# Mount Piper Power Station Ash Placement Project Modification 1

## Lamberts North Ash Repository Upgrades

State Significant Development Modification Assessment (MP09\_0186 MOD 1)

September 2021

Figure 2 | Conceptual Ash Placement Cell Design (Source: Modification Report (MOD 1), EnergyAustralia)

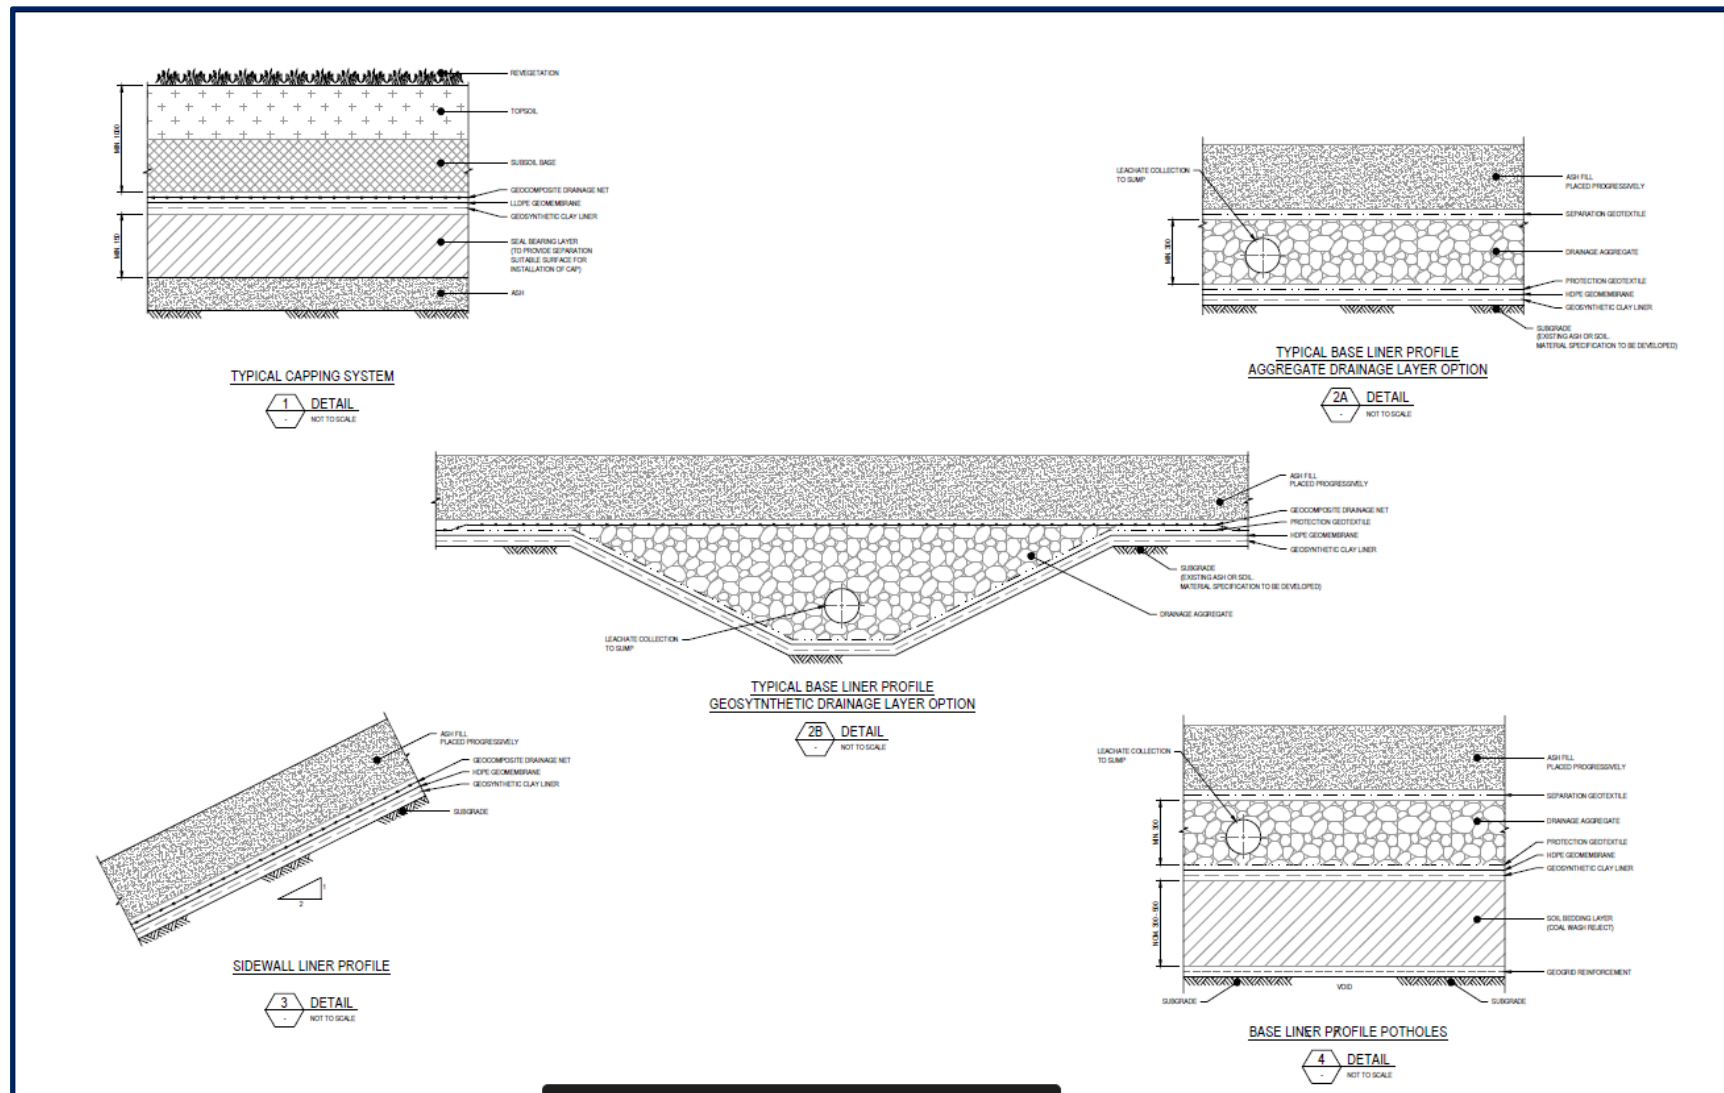
EnergyAustralia's water assessment found that potential adverse impacts to surrounding surface water and groundwater would be mitigated, compared to the approved project, provided the proposed works are installed in accordance with the concept design (see **Figure 2**) and implemented in accordance with the minimum standards required by the EPA Landfill Guideline.

However, the EPA advised that there were limited details provided on the sizing and layout of the leachate collection dams and recommended that prior to the commencement of operation, EnergyAustralia demonstrate that the design is consistent with the EPA Landfill Guideline. The Department supports EPA's position and has recommended conditions to this effect.

The EPA recommended a condition that EnergyAustralia must demonstrate that the leachate management system as constructed is consistent with the EPA Landfill Guideline prior to operation.

**Figure 3 | Existing Project and Proposed Modification (Source: Modification Report (MOD 1), EnergyAustralia)**

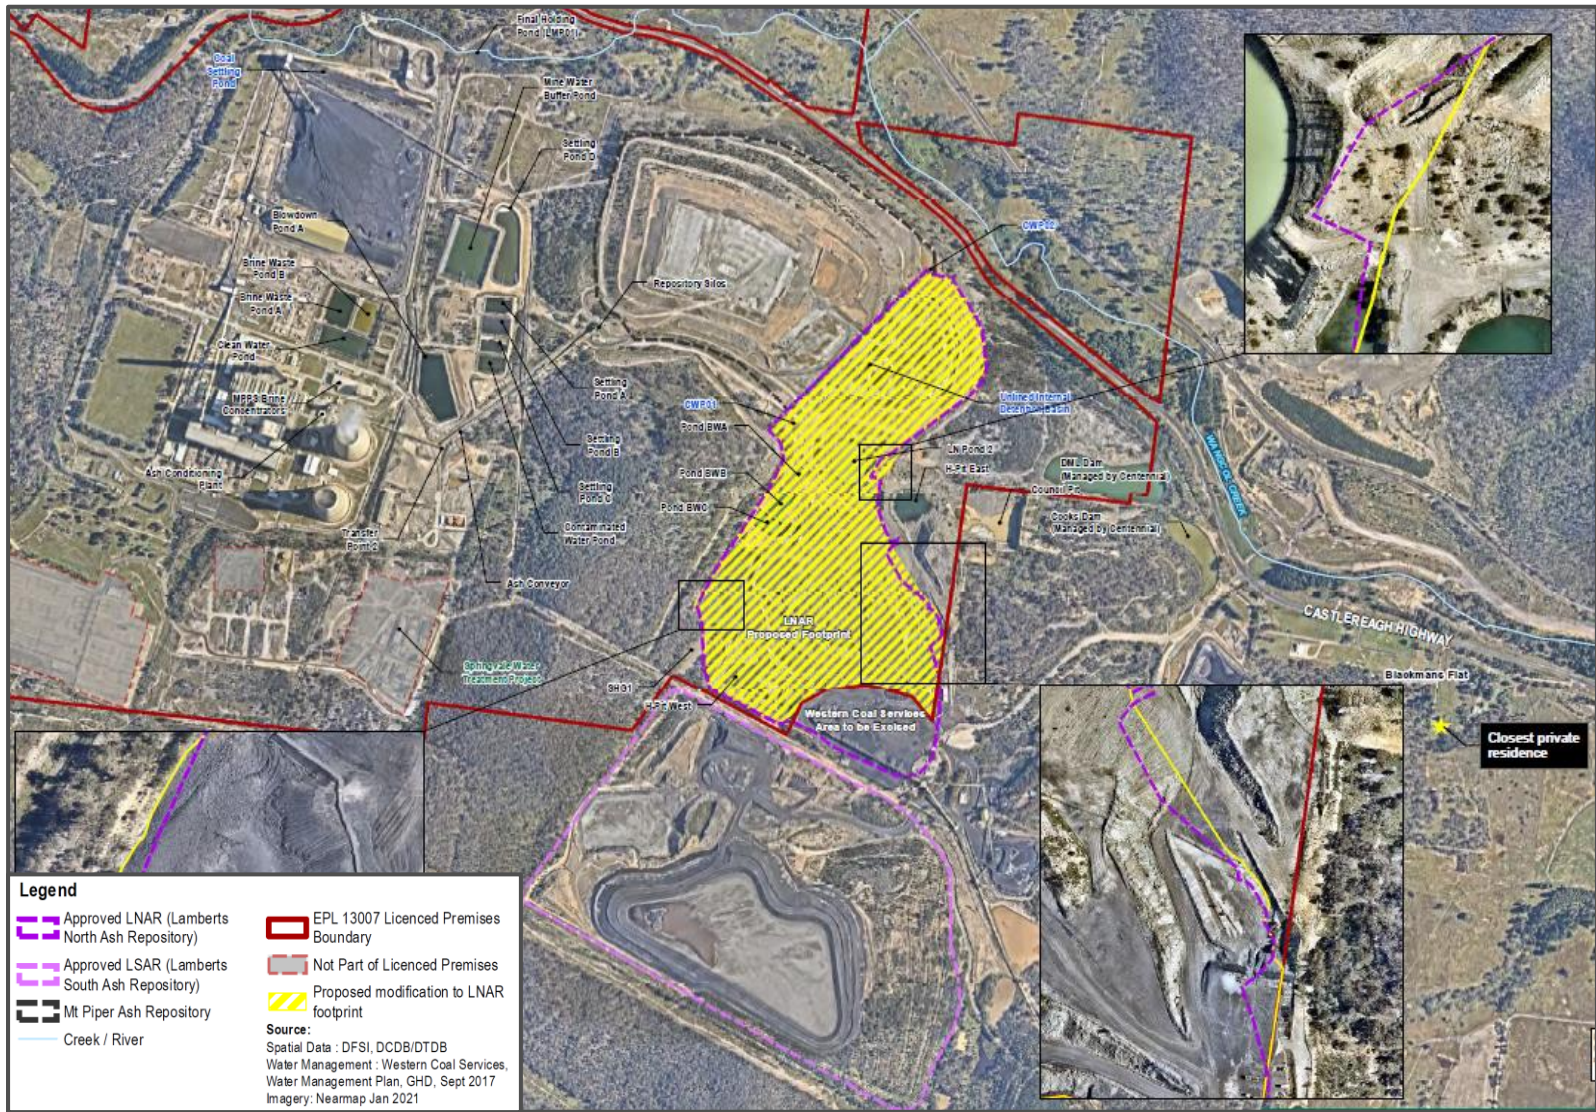
The approved project and proposed modification to the LNAR boundary are shown in **Figure 3**, with indicative staging of the LNAR, along with landform integration with the MPAR shown in **Figure 4**. The Department notes that the green area on **Figure 4** is an ash emplacement area for the proposed Mount Piper Energy Recovery Project, which is currently under separate assessment by the Department.

**Figure 4 |** Emplacement Staging (Source: Modification Report (MOD 1), EnergyAustralia)

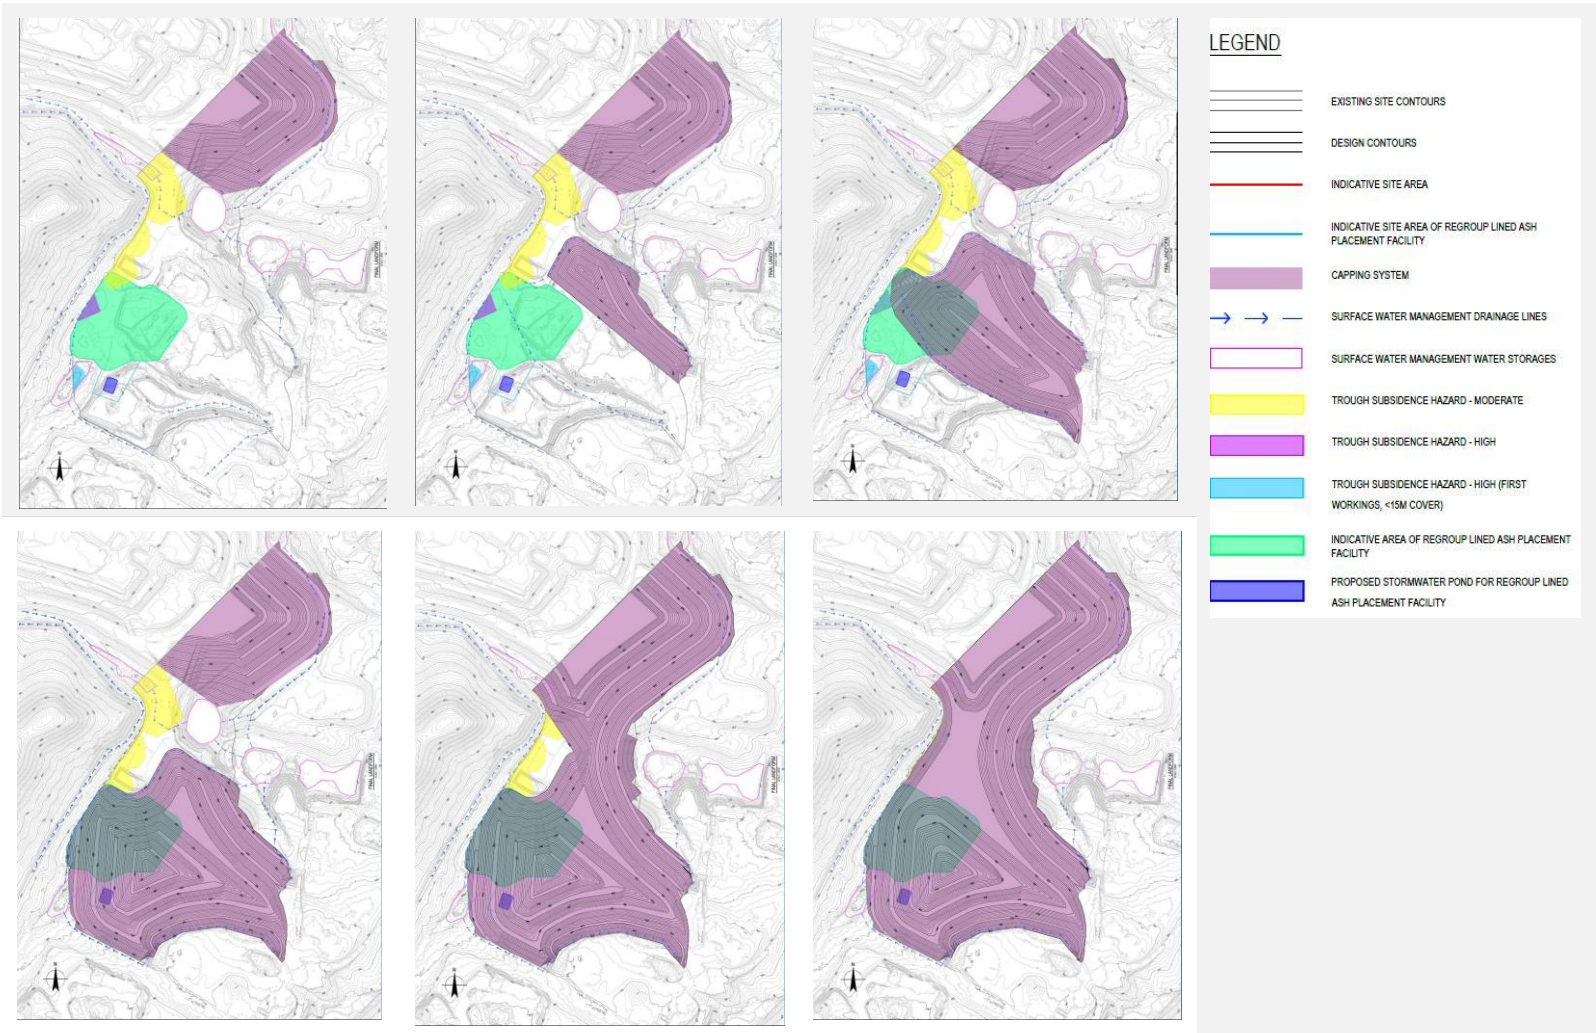
Detailed design of the waste cells and leachate collection system would also need to consider potential subsidence risks associated with earlier underground (bord and pillar) mining operations, including additional bedding materials to stabilise these workings (see **Figure 4**).
